Mobile Intel® Celeron® Processor on .13 Micron Process in Micro- FCPGA Package

Specification Update

September 2004

Document Number: [251309-022](#)

Figure 12. System Bus Reset and Configuration Timings

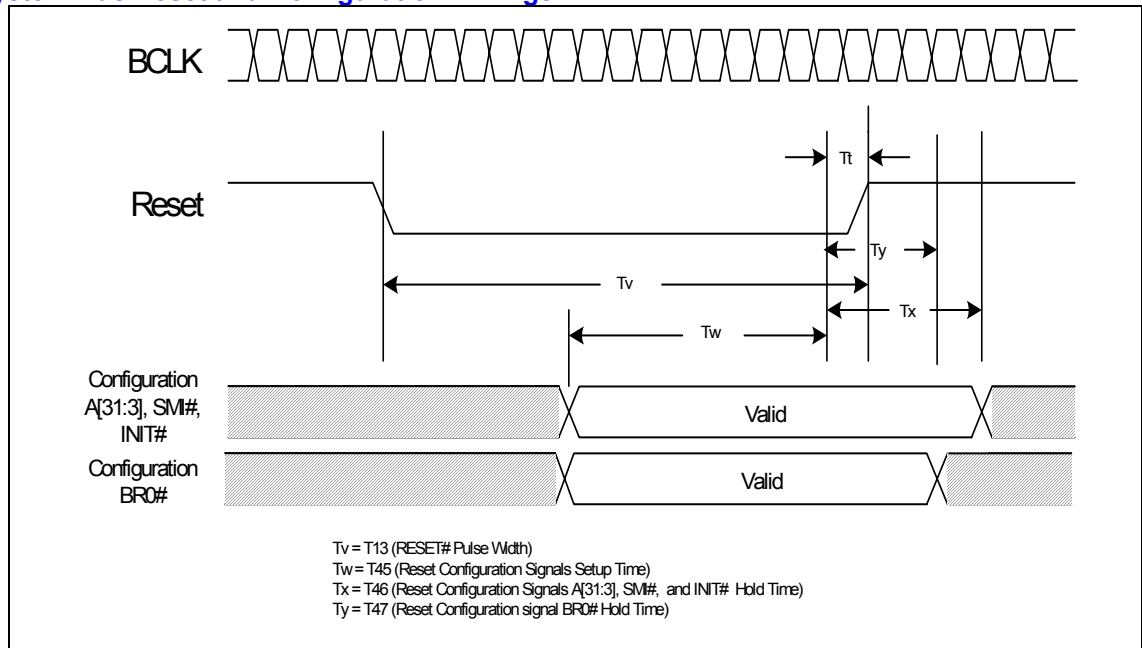
2. BR0# Maximum Hold Time Specification Change

The BR0# maximum hold time has changed to 2 BCLKs. This change will be shown in the “System Bus AC Specifications (Reset Conditions)” table and “System Bus Reset and Configuration Timings” figure of the *Mobile Intel® Celeron® Processor on .13 Micron Process in Micro-FCPGA Package Datasheet*. This change will be incorporated in the next revision of the datasheet.

The following figure is modified to reflect this change:

T# Parameter	Min	Max	Unit	Figure	Notes
T45: Reset Configuration Signals (A[31:3]#, BR0# INIT#, SMI#) Setup Time	4		BCLKs	13	1
T46: Reset Configuration Signals (A[31:3]#, INIT#, SMI#) Hold Time	2	20	BCLKs	13	2
T47: Reset Configuration Signal BR0# Hold Time	2	2	BCLKs	13	2
